FIELD CHANGE NO. 1 - NOVEMBER 17, 2009

**CITY ROCKWALL, TEXAS**  
SQUABBLE CREEK  
30 INCH FORCE MAIN  
PLAN AND PROFILE  
STA. 25+00 TO STA. 30+00

BHC  
PROJECT NO.  
2007-110  
SHEET NO.  
**8**  
July 2009

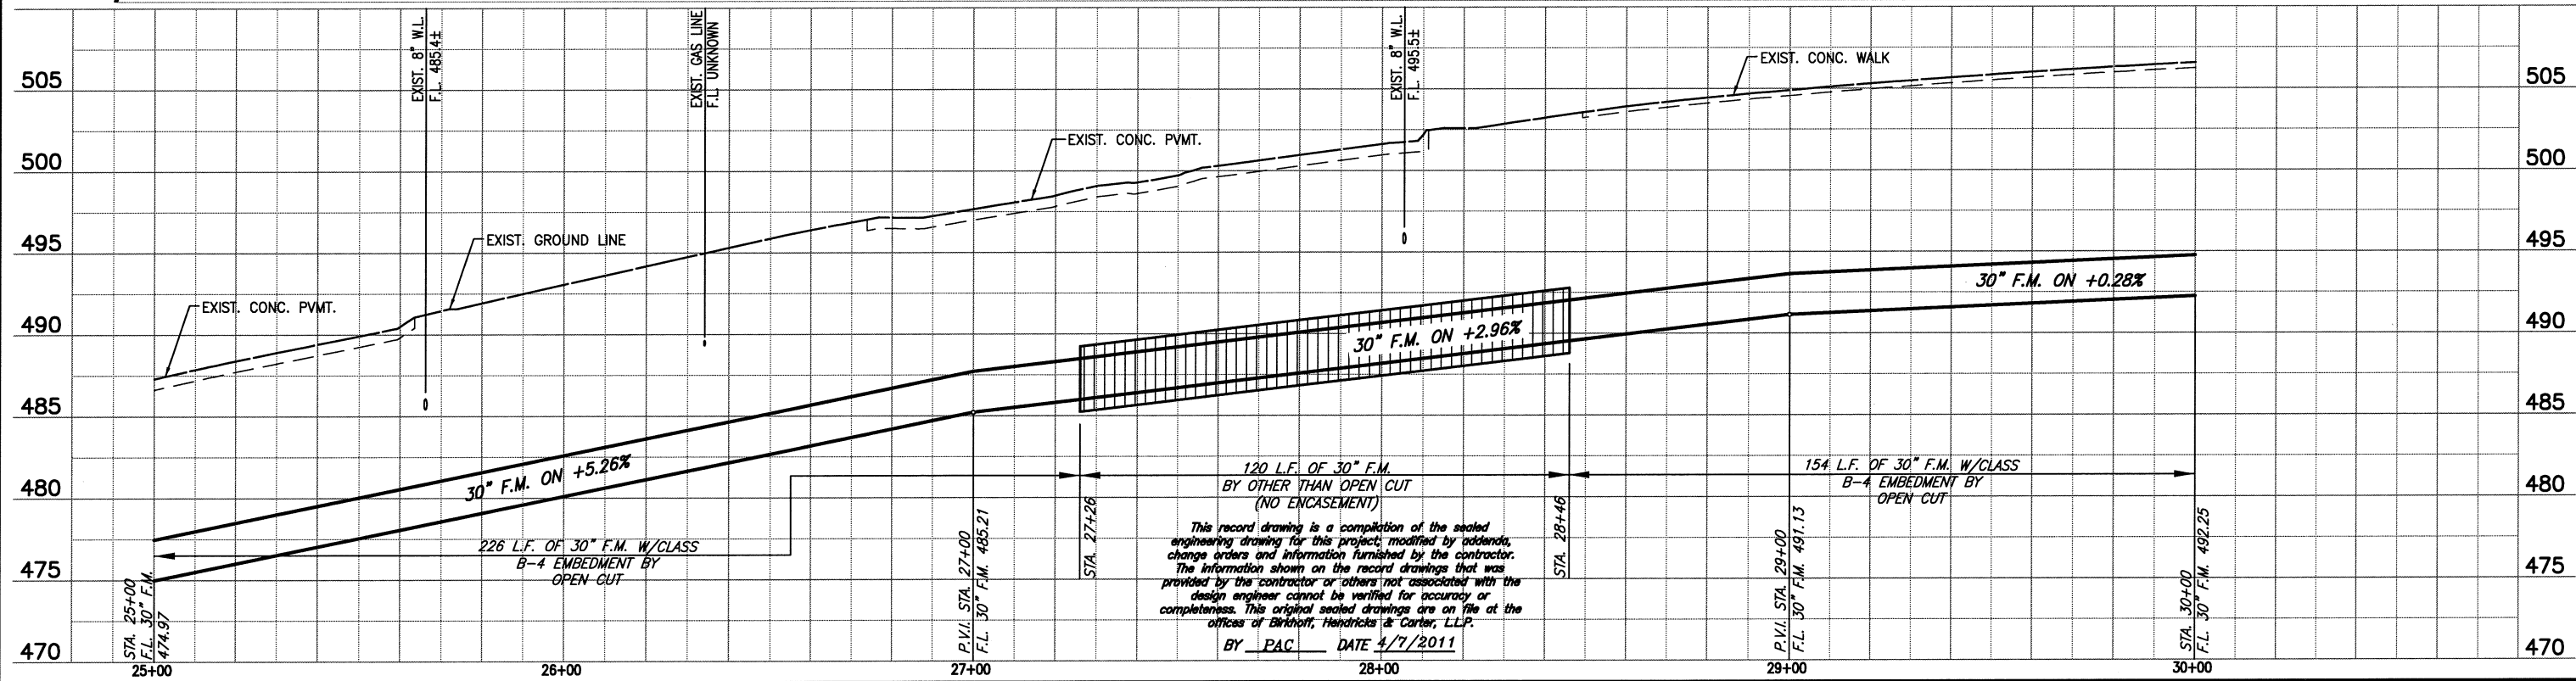
STA. 27+26 TO STA 28+46  
FURNISH & INSTALL  
120 L.F. 30" FORCE MAIN  
BY OTHER THAN OPEN CUT  
(NO ENCASEMENT)
